To: Dr. Tom Jungling of NRC

Dr. Lawrence P. Boesch

Problems we observe with respect to corrosion work at BWIP based on 18 & 19 June Corrosion Panel Materials Renew Board Meeting. (and the NWIS meeting at Livermore.)

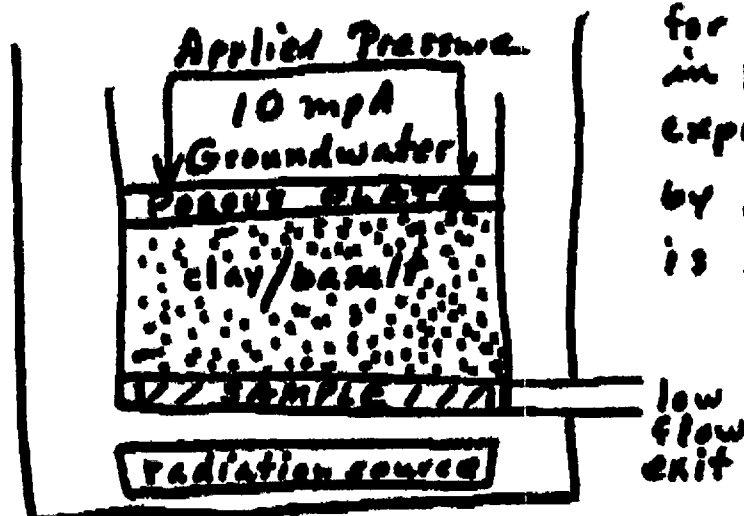
6. Dr. Moler recommends performing an experiment

for corrosion, as suggested in point 1. based on an experimental apparatus used by Pusch, and others. This is shown at the left.

The experiment ought to be statistically designed
